## SERVICE BULLETIN

**APPLICABILITY:** 2020-24MY Legacy & Outback 2.5L  
 2017-24MY Impreza & Crosstrek  
 2019-23MY Forester  
 2022-23MY BRZ

**NUMBER:** 09-115-24R

**SUBJECT:** Oxygen Sensor Design Change / P0137, P0138, P0140, & P0141

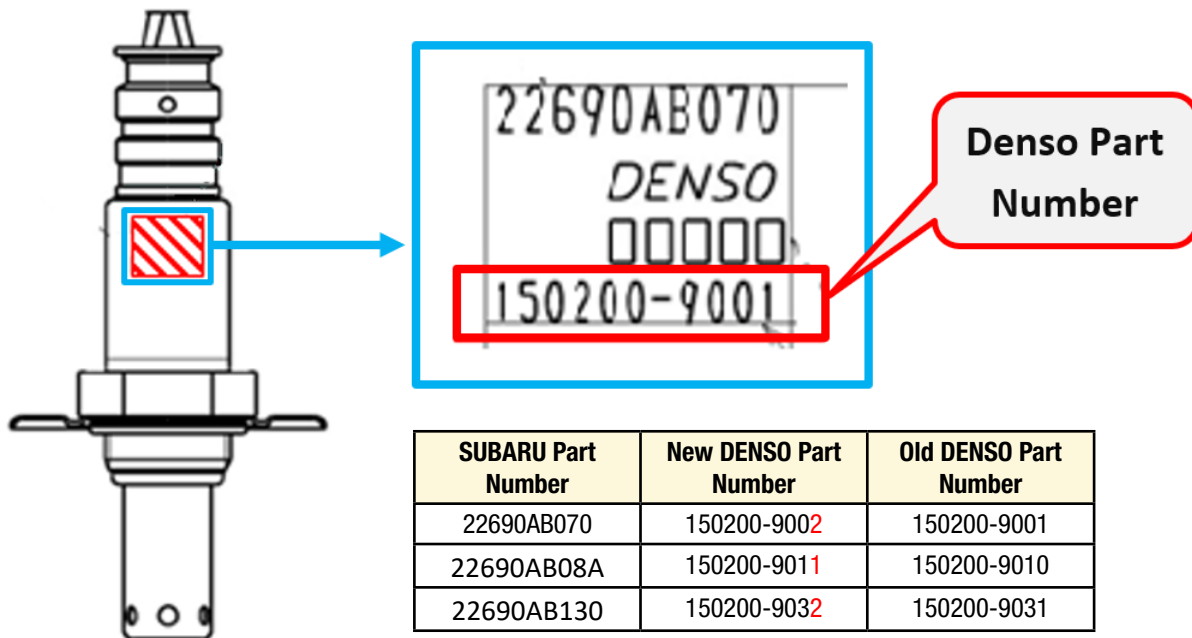
**PART IDENTIFICATION:**

The part numbers have not been changed. The new parts can be identified by the Denso part number engraved on the sensor.
